meeting minutes

Project No.: R3001.405.00 **File No.(s):** 0.10.0

Project Name: University of Wisconsin-La Crosse- New Student Fieldhouse & Soccer Support Facility (DFD 1512I)

Subject: Exercise and Sport Science User Group Meeting

OVERALL SITE

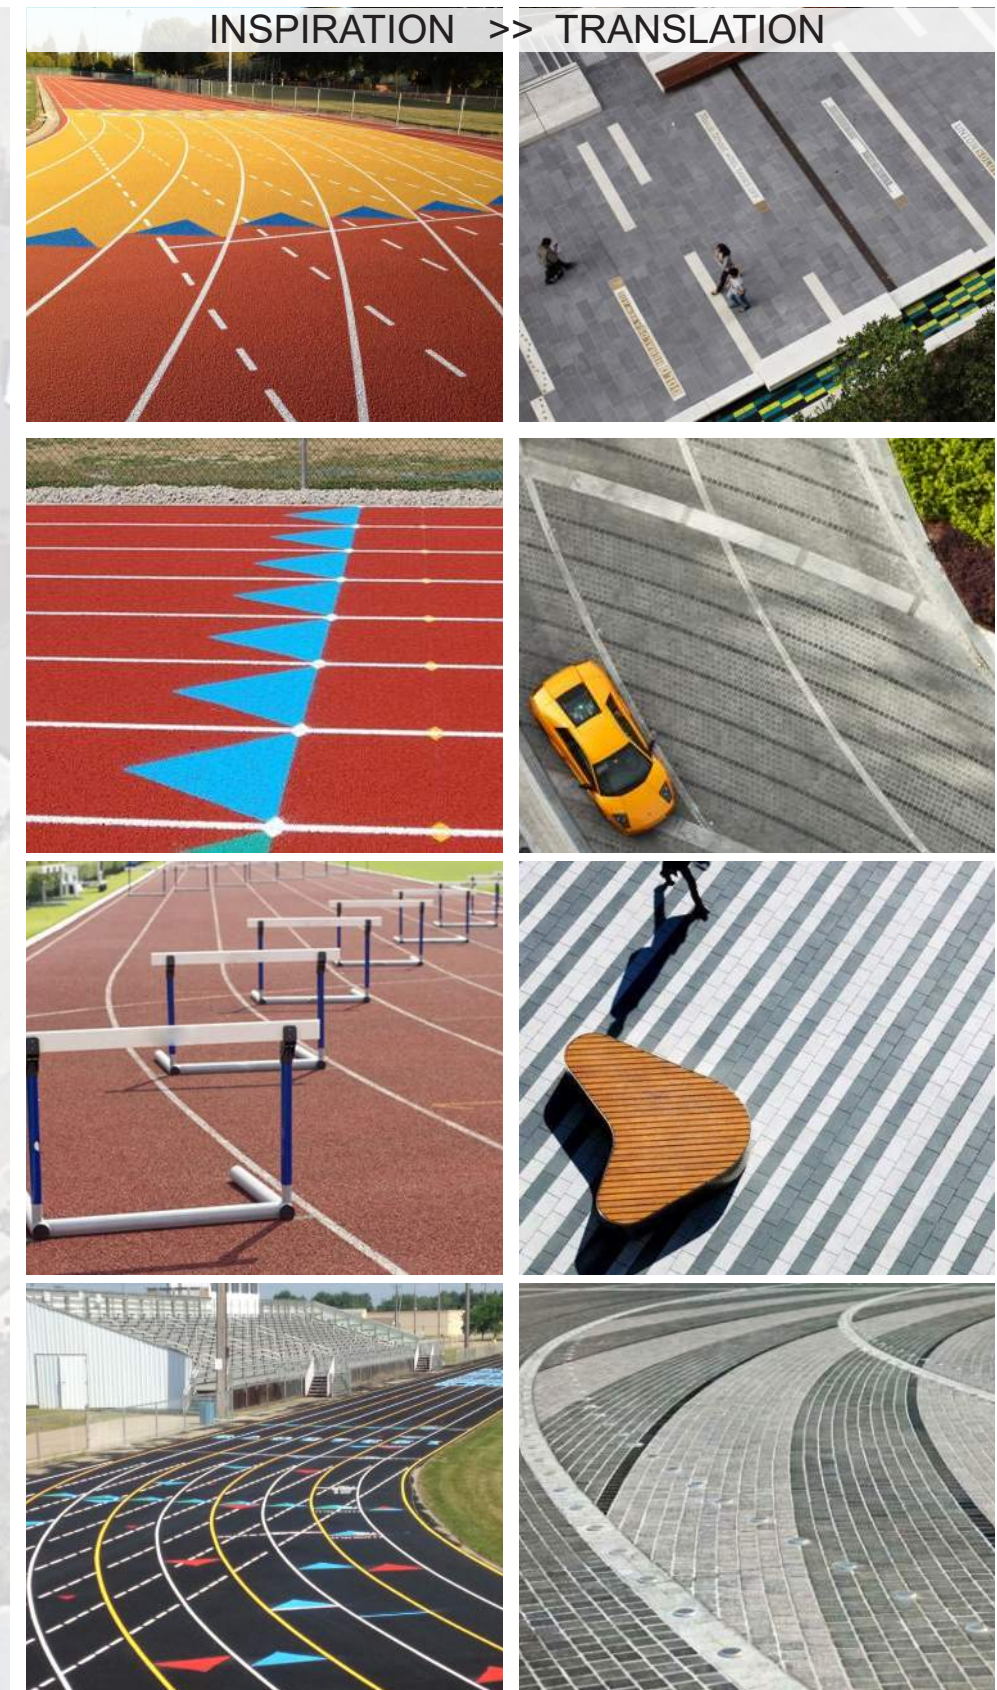
- 10) MG believed Training as shown is undersized for the largest events like the State Track Meet. Original program area was 500 SF and is currently shown at 1,000 SF.
- 11) ESS requests 20 client parking spaces minimum on site. 25 spaces are desired. MG believed on-street parking is not typically available on Pine street during regular client hours (spaces are already occupied by 8:00am).
- 12) Exterior images: liked small / shallow peaks like at Great Hall & Stadium

1 FLOOR PLAN - LEVEL 1
1/8" = 1'-0"

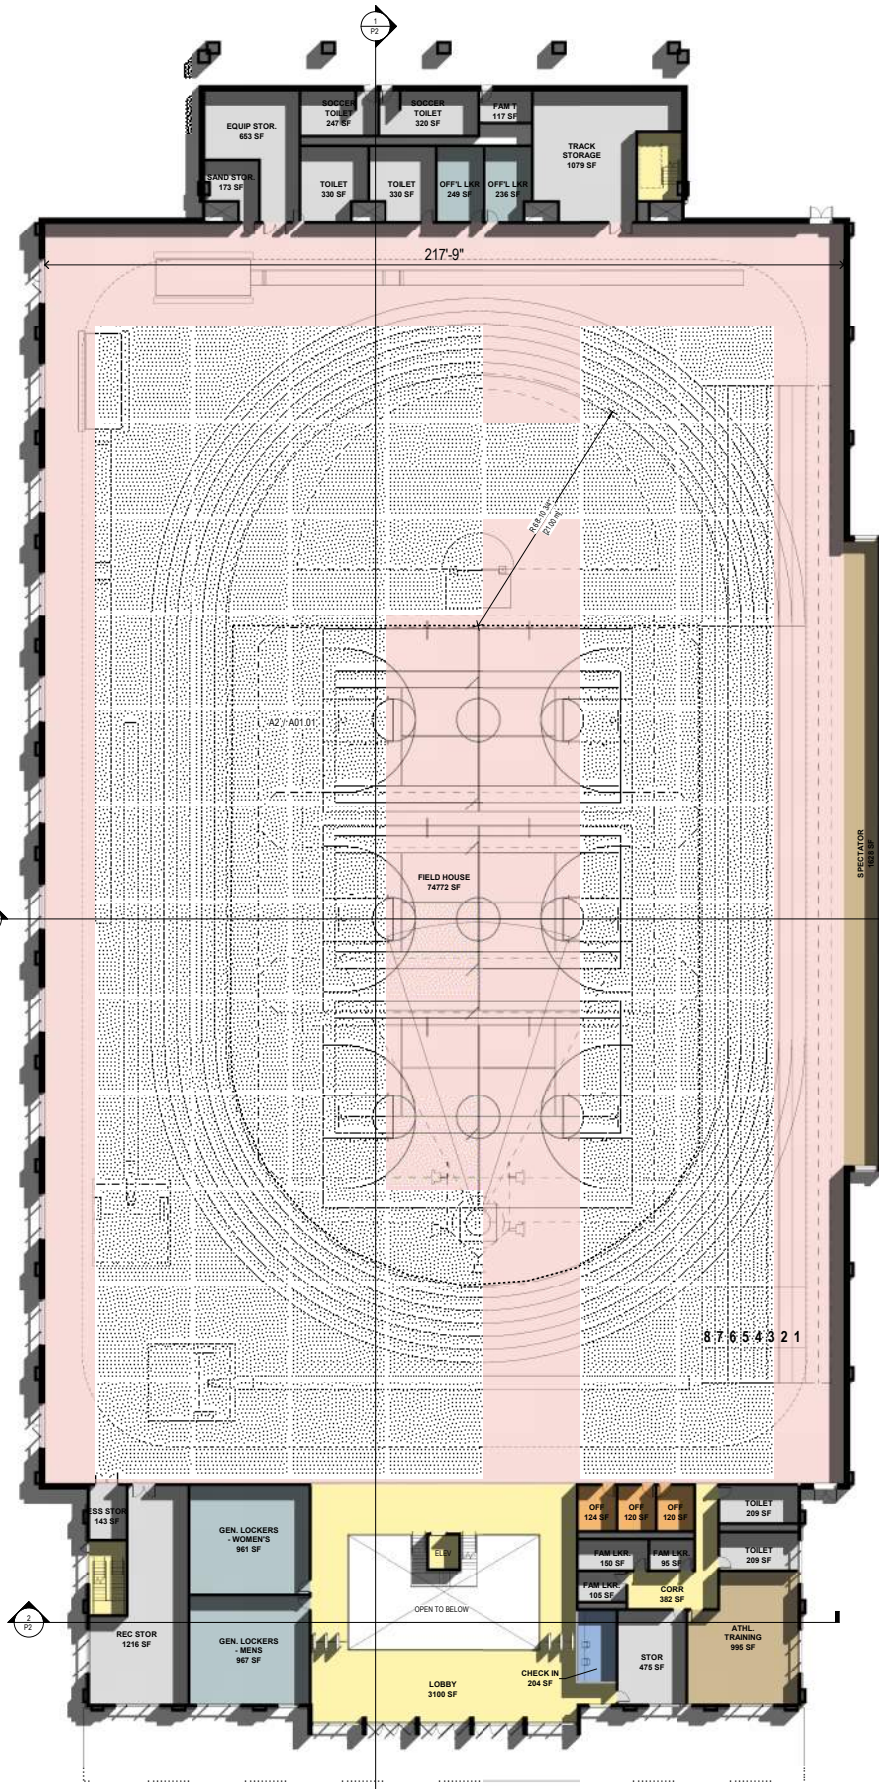
- 6) MG requested a fixed desk or counter at Level 2 to use as a "home base" for ESS staff. A location near the elevator and stairs would be best.
- 7) Athletic Training location on Level 1 is OK for ESS. Liked the natural light. Privacy for those in Training (related to views from the exterior) should be taken into account.

2 FLOOR PLAN - LEVEL 2
1/8" = 1'-0"

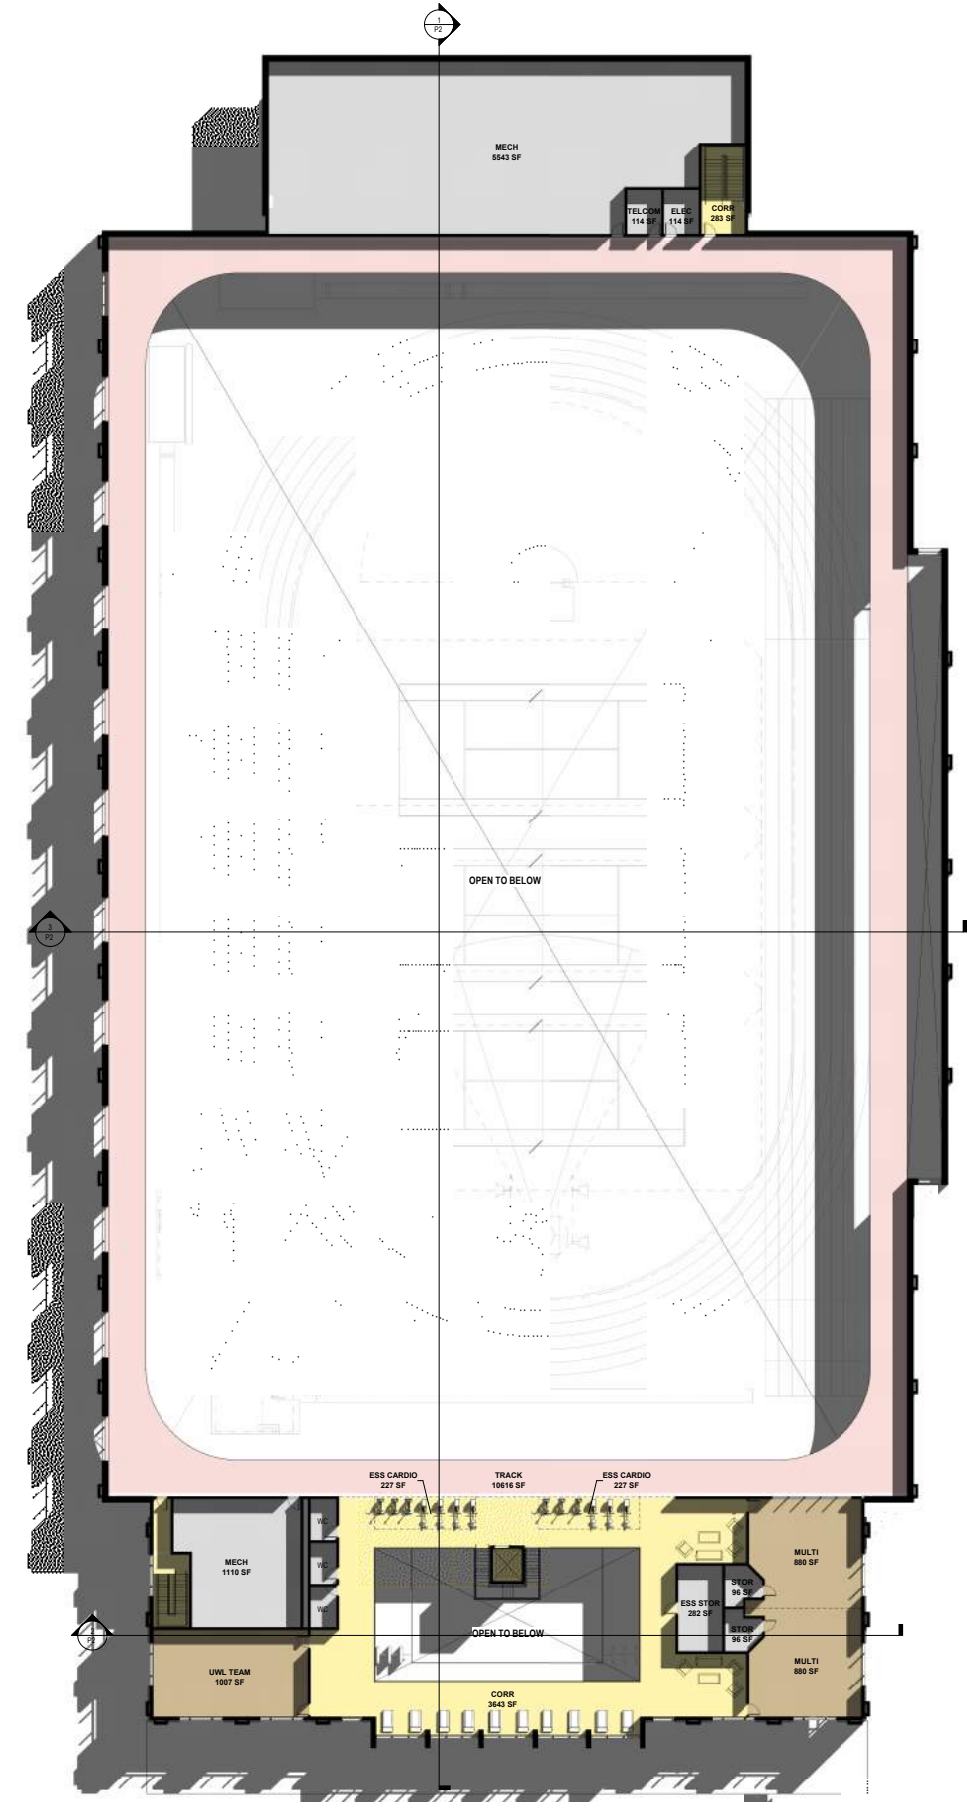
- 1) Liked the relationship of the new building to the existing stadium.
- 2) The "lounge" area shown on Level 2 outside of the Multipurpose rooms would be a good place for blood pressure activities. Currently this is "bonus space" not specifically listed in the Program.
